The Commission has issued the enclosed Amendment No. 124 to Facility Operating License No. DPR-49 for the Duane Arnold Energy Center. This amendment consists of changes to the Technical Specifications in response to your application dated June 14, 1985.

This amendment revises the Amendment No. 121 effective date from May 28, 1985 to July 31, 1985.

Amendment No. 124
License No. DPR-49

SUPPORTING AMENDMENT NO. 124 TO LICENSE NO. DPR-49

FIGURE 3.6-1

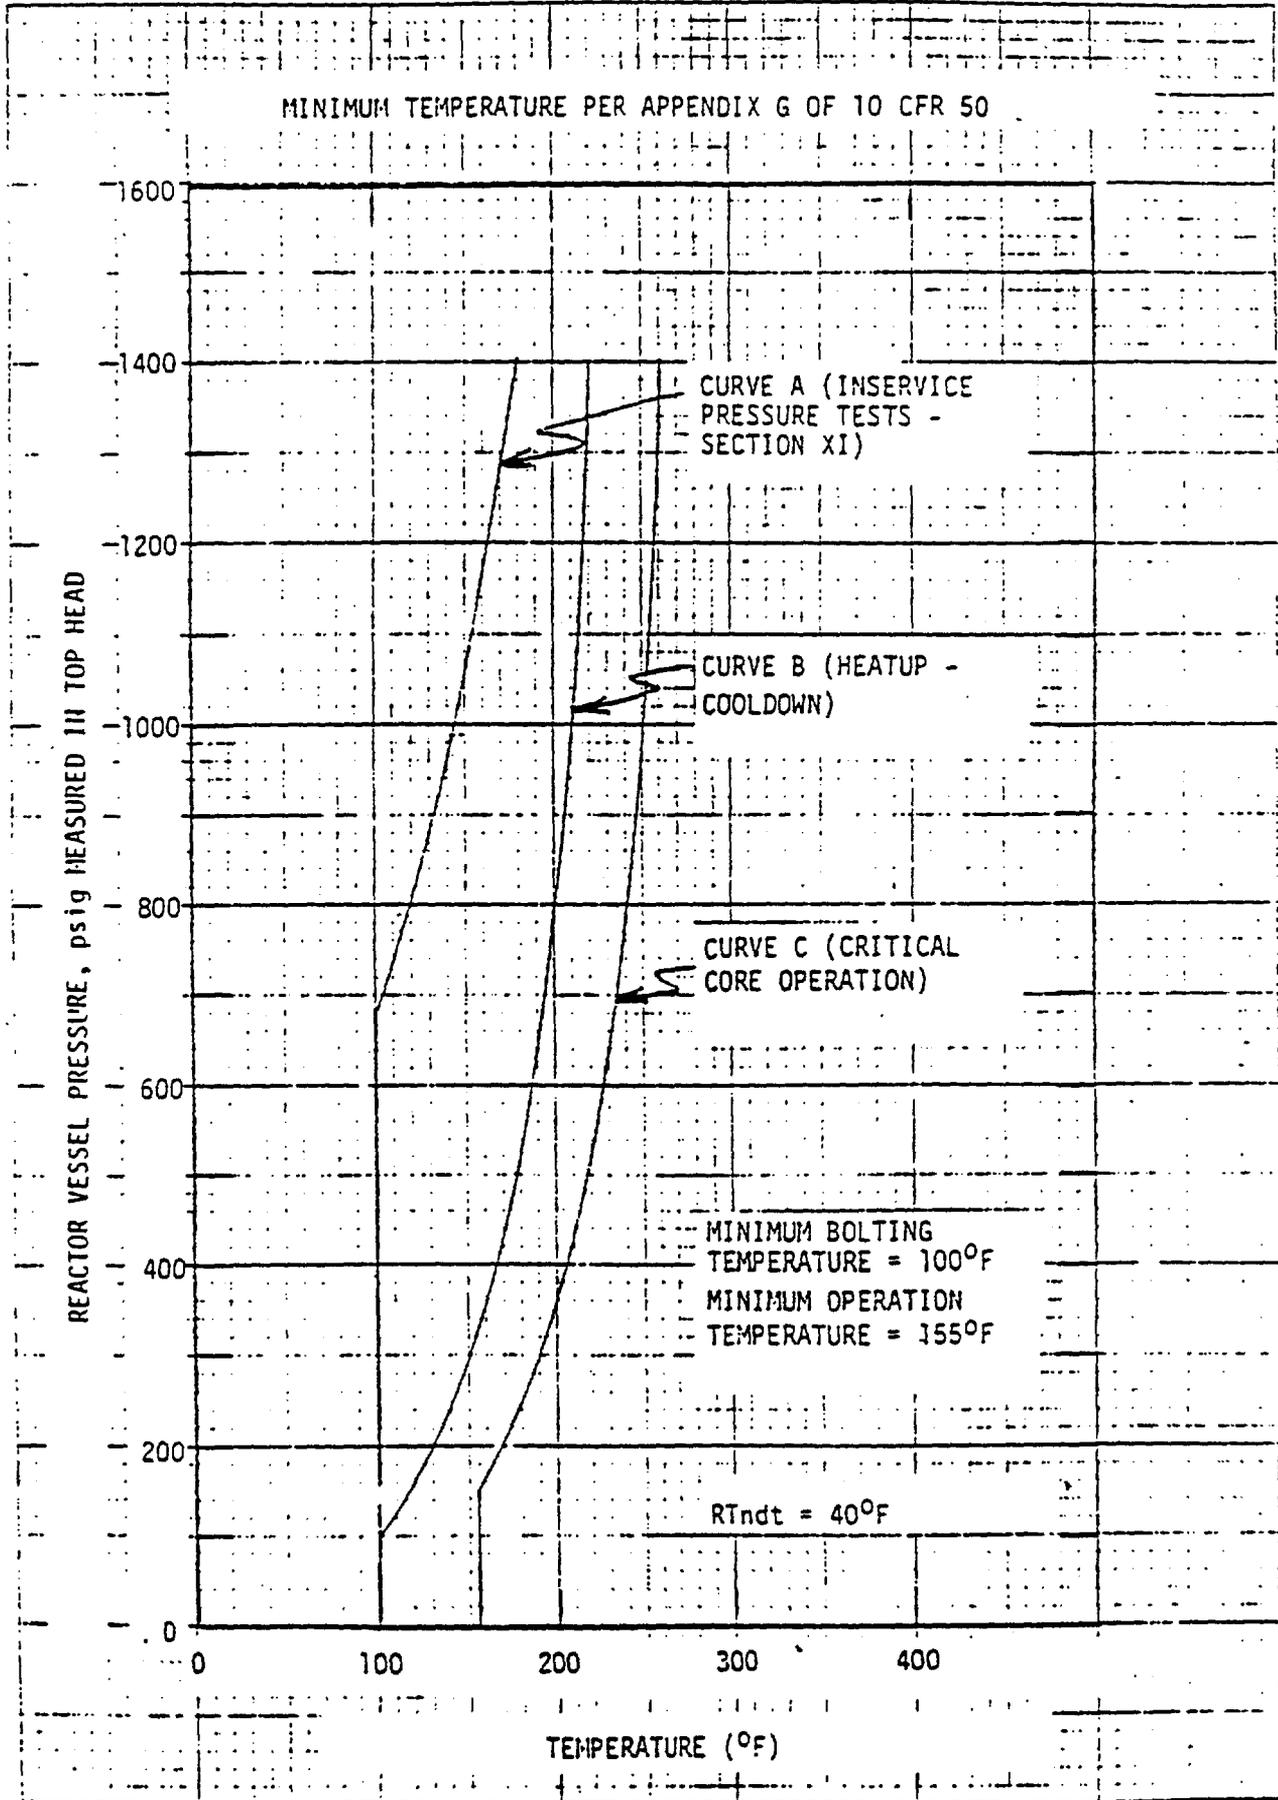
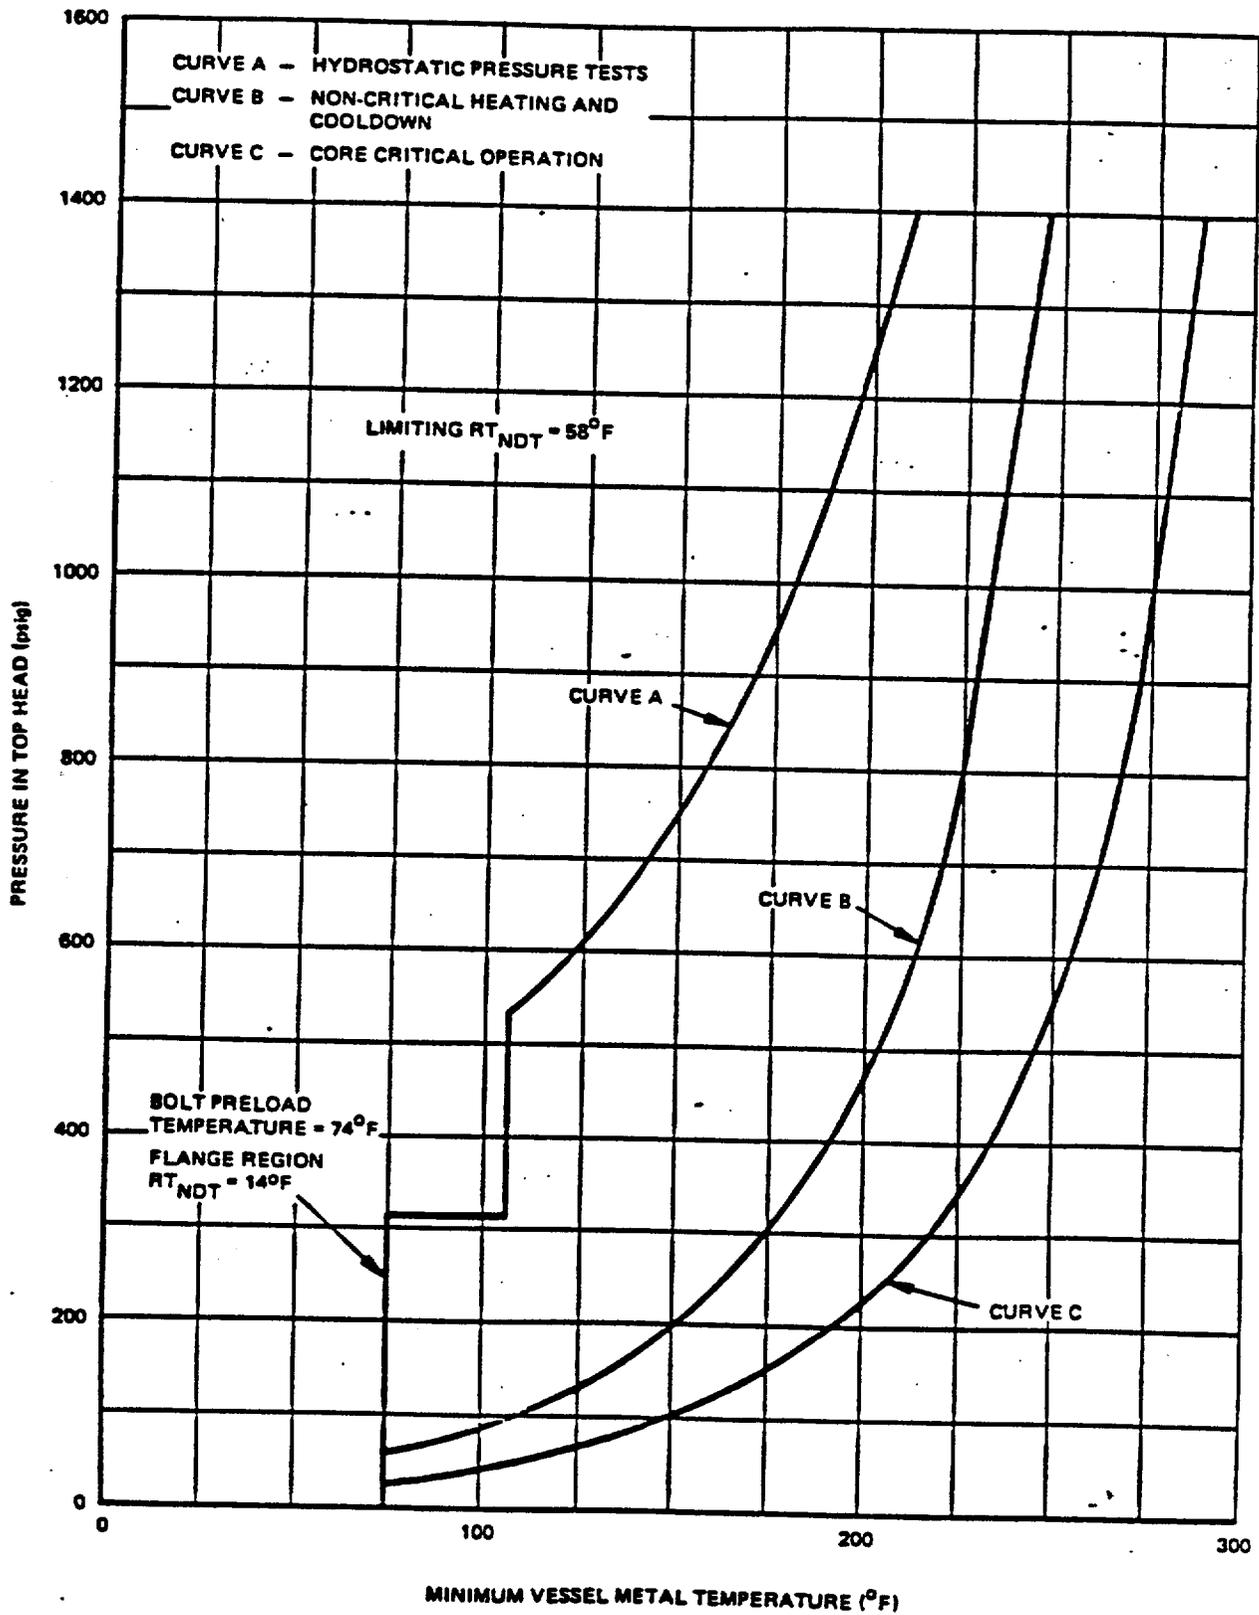
2. Accordingly, the license is amended by revising the effective date of Amendment No. 121 from May 28, 1985 to July 31, 1985.

The operating limits in Figure 3.6-1 are derived in accordance with 10 CFR 50 Appendix G, May 1983 and Appendix G of the ASME Code. Conditions in three regions influence the curves: the closure flange region, the non-beltline region which includes most nozzles and discontinuities, and the beltline region which is irradiated with fluence above 10^{17} n/cm² during the vessel operating life. Irradiation causes an increase in the nil-ductility temperature (RT_{NDT}) of the beltline materials, possibly to the point where the beltline region impacts the pressure-temperature limits for the vessel. However, for Figure 3.6-1, effective to 12 EFPY, the beltline which has an

RT_{NDT} of 40°F is less limiting than the non-beltline regions which generally experience higher stresses at nozzles and discontinuities. The limiting RT_{NDT} of 58°F for the Standby Liquid Control Nozzle (N10) is the highest RT_{NDT} of any component in the non-beltline region.

The closure flange region, with RT_{NDT} = 14°F, has a bolt preload and minimum operating temperature of 74°F. This exceeds original requirements of the ASME Code (Winter 1967 Addendum) and provides extra margin relative to current ASME Code requirements.

* Remove these pages from the Technical Specifications after July 31, 1985.

** Effective on July 31, 1985.
